PROJECT:	Wells County Public Library Renovations	SUPPLEMENTAL INFORMATION (SI) NUMBER:	55R1
		DATE OF ISSUE:	7/7/2020
OWNER:	WCPL	CONTRACT FOR:	General Construction
		CONTRACT DATED:	12/9/2019
TO CONTRACTOR:	CME Corporation	ARCHITECT'S PROJECT NUMBER:	19067

SUMMARY: TECH SERVICES 111 CASEWORK AND CHILDREN'S HALF CIRCLE TABLES
DESCRIPTION:

Prime Contract Potential Change Order #062: SI-55.1 - Tech Services Casework and Half Circle Tables

2 TECH SERVICES - WEST 1

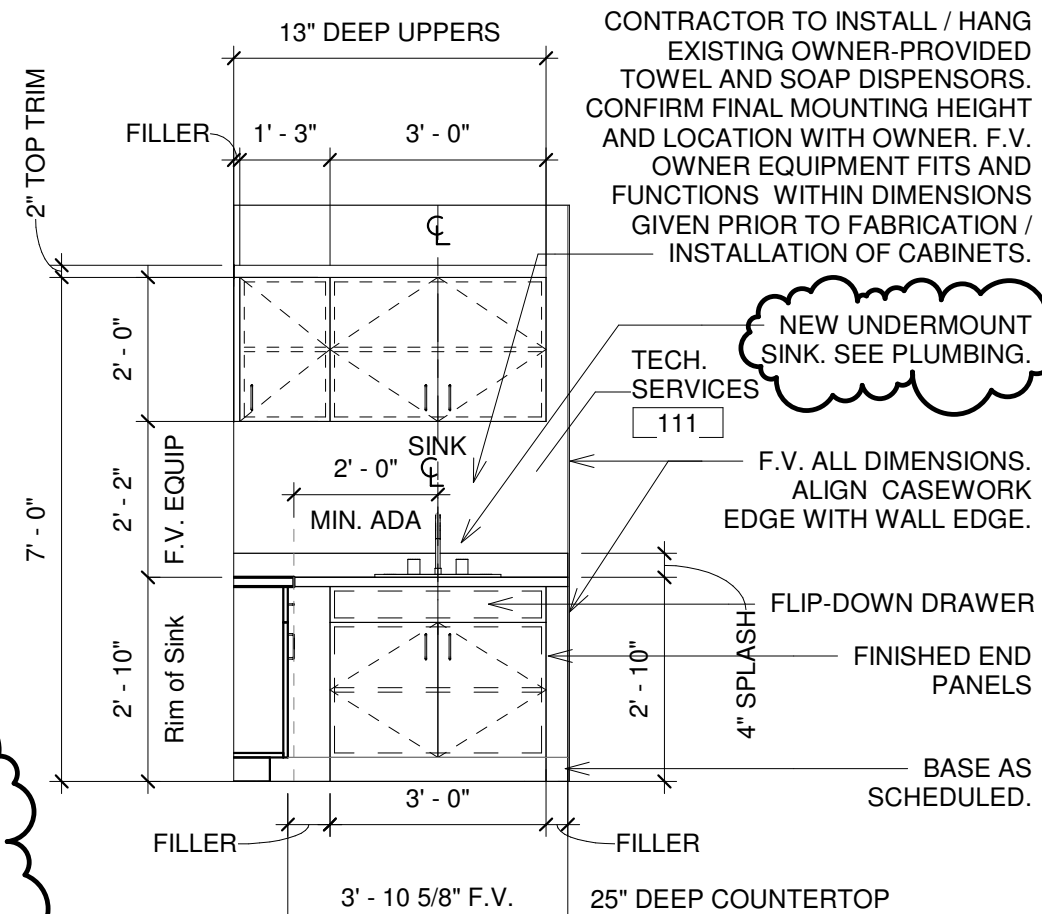
NOTE: Since the sink at the west wall condition (3/SI55.1 R1) is now an undermount sink, the related countertop at this location and at 2/SI55.1 R1 shall be 34" AFF. This revised condition may allow for proper installation of the owner-supplied wall oven.

HALF CIRCLE TABLES

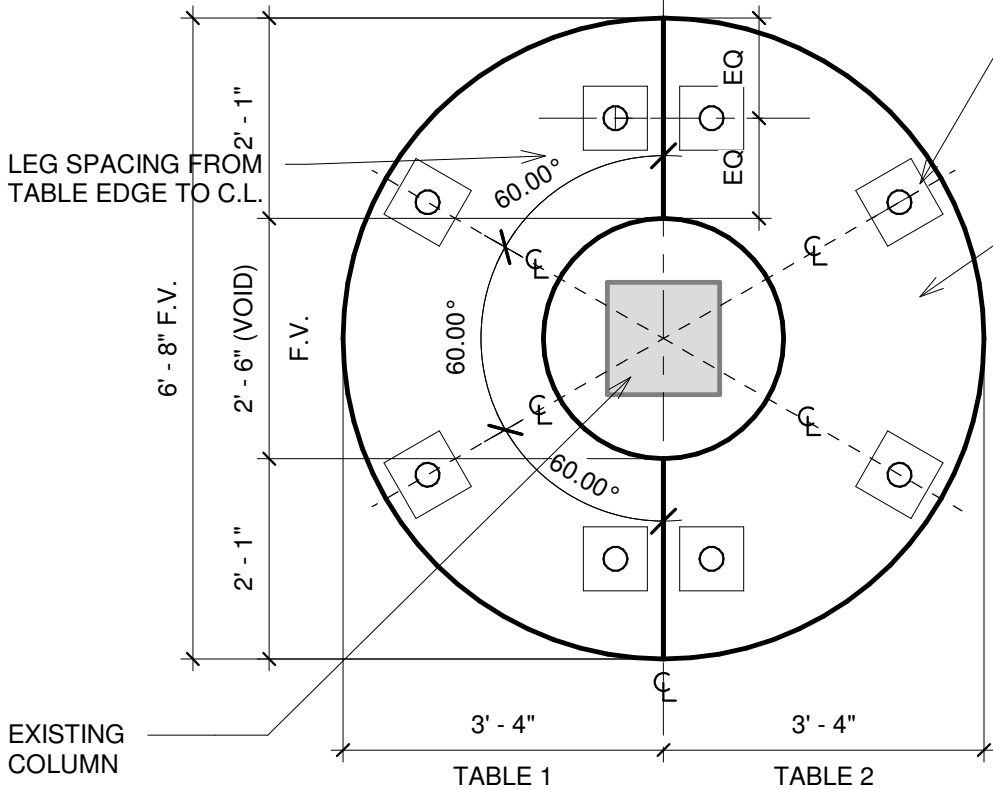
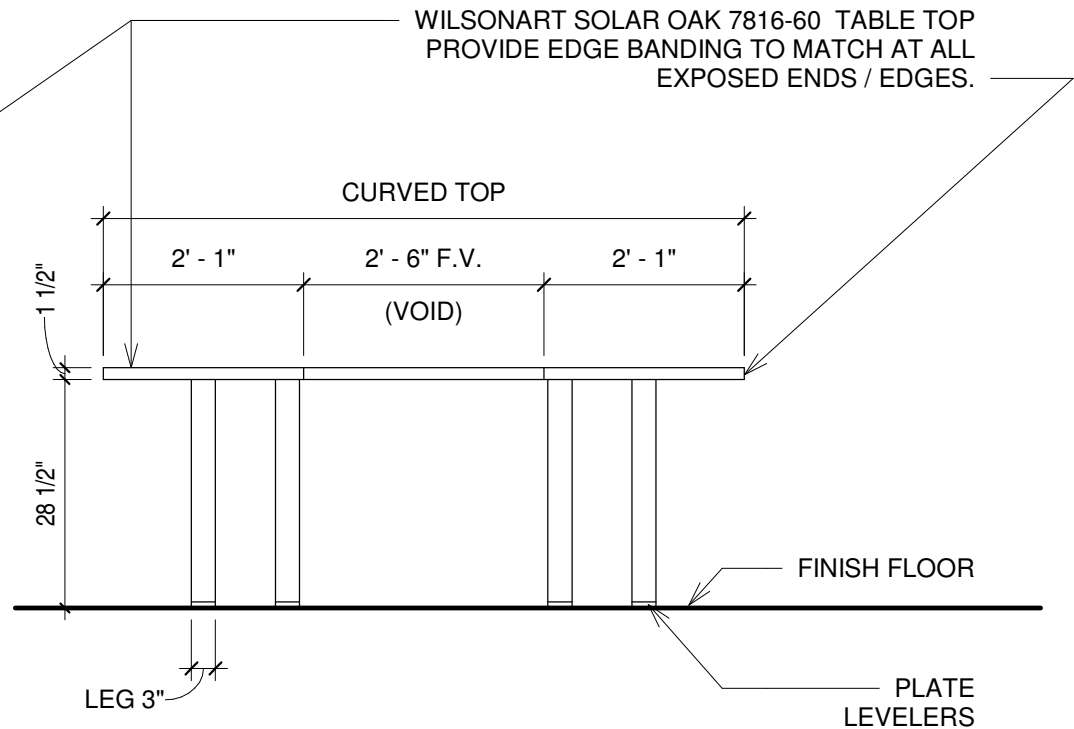
CME is proposing a voluntary alternate to deduct \$859.71 from the PCO #62 to substitute the same adjustable metal legs used in the A/V Office in lieu of the legs specified.

We can substitute the metal legs for our stock legs finished in anodized aluminum. These are typical to what was supplied in the work room. (Cost of legs is \$1,450.00)

PROVIDE LINK / GANGING DEVICE BETWEEN
TABLES BASIS OF DESIGN = MOORECO
ITEM NO. 82558 GANGING DEVICE. TWO (2)
TOTAL GANGING DEVICES - ONE (1) AT
EACH JOINT BETWEEN TABLES

TABLE LEG BASIS OF DESIGN = TL28P-3 - 28-1/2" TABLE LEG 3"
DIAMETER WITH PLATE LEVELER. COLOR = MATTE BLACK. USE
MFR. RECOMMENDED OFFSETS FROM EDGE CONDITIONS.
CONTRACTOR TO PROVIDE MOUNTING HARDWARE AS
REQUIRED.
